Pavilion Park Plaza Comment Survey Results Data Visualizations

Design features you like

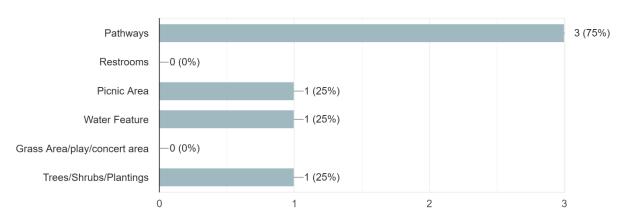
10 responses

Design features you do not like

4 responses
